COMBUSTION ENGINEERING, INC.

License SNM-1067
Docket 70-1100
July 3, 1969

Combustion Engineering, Inc., requests that its Source & Special Nuclear Material License #SNM-1067 be amended to allow the use of its fuel bundle shipping container, identified as CE Model 927A, for delivery of the Palisades Fuel Bundles to a carrier for transport.

Application for Licensing of Combustion
Engineering, Inc., Fuel Bundle
Shipping Container
Model: CE 927A

Figure
1

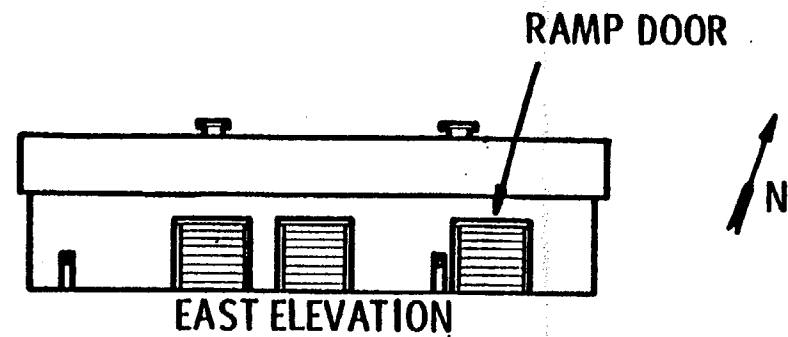
This page indicates that Radiation Monitor - Bldg. #21 is located on the inner East Wall rather than the inner West Wall as stated in the original application.
